RE: Comparison between before & after for EX240W

EX240W (FCC ID: GCJEX240W)

Model: EX240W

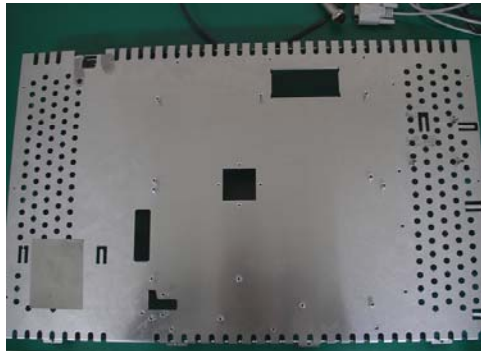
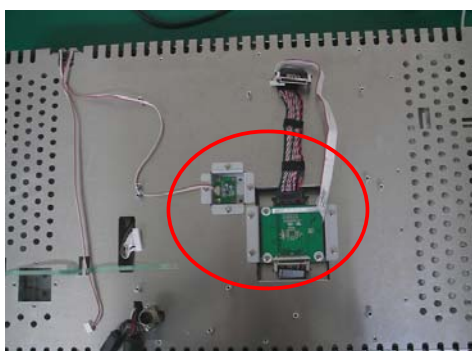
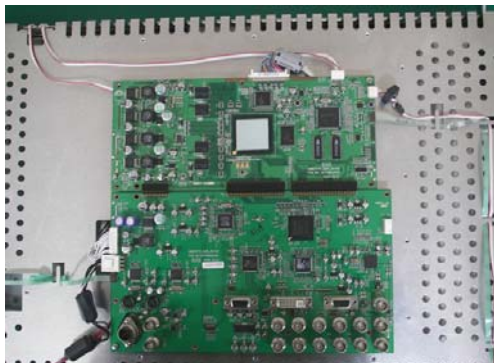
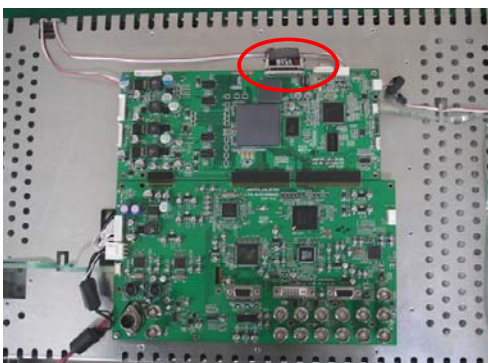
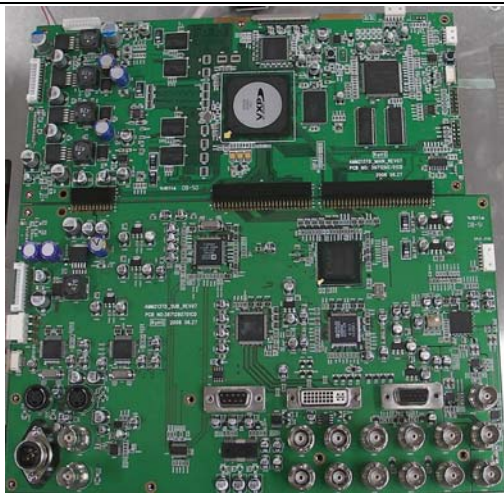
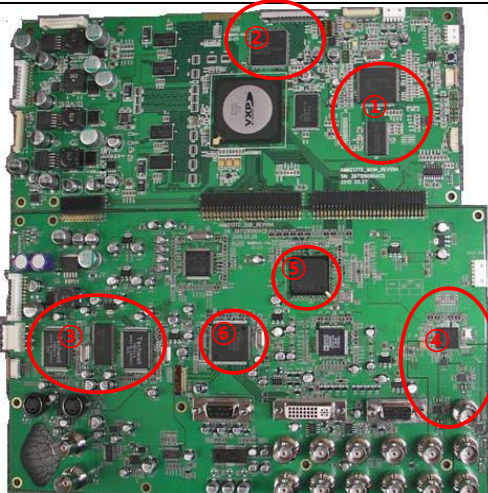
| Item                                                                                                                                                                                                                                                                                                                                                                                                                                                                                                            | Before                                                                             | After                                                                                              |
|-----------------------------------------------------------------------------------------------------------------------------------------------------------------------------------------------------------------------------------------------------------------------------------------------------------------------------------------------------------------------------------------------------------------------------------------------------------------------------------------------------------------|------------------------------------------------------------------------------------|----------------------------------------------------------------------------------------------------|
| Rev07 Board --> Rev09 Board changed.                                                                                                                                                                                                                                                                                                                                                                                                                                                                            |                                                                                    | <br>CSC Board |
| 1. U-COM change : SH7145 --> SH7085<br>2. LVDS IC change : DSC387AVJD --> THC63LVD1023B<br>3. VIDEO Decoder change : VPX3226 --> TW9919<br>4. Device change for 3G-SDI :<br>Equalizer IC : GS1574A --> GS2984 , Cable Driver IC : GS1578 --> GS2978<br>De-Serializer : GS1559 --> GS2960 , SDI-S/W : SY58609UMG<br>5. To improve CPLD problem, change to FPGA : XC2C512-7FG324C --> XC3S400AN-5FGG400C<br>6. TMDS IC change : Sii1161CT--> Sii9125<br>7. CSC board add : For Auto Color Tuning, added CSC board |                                                                                    |                                                                                                    |
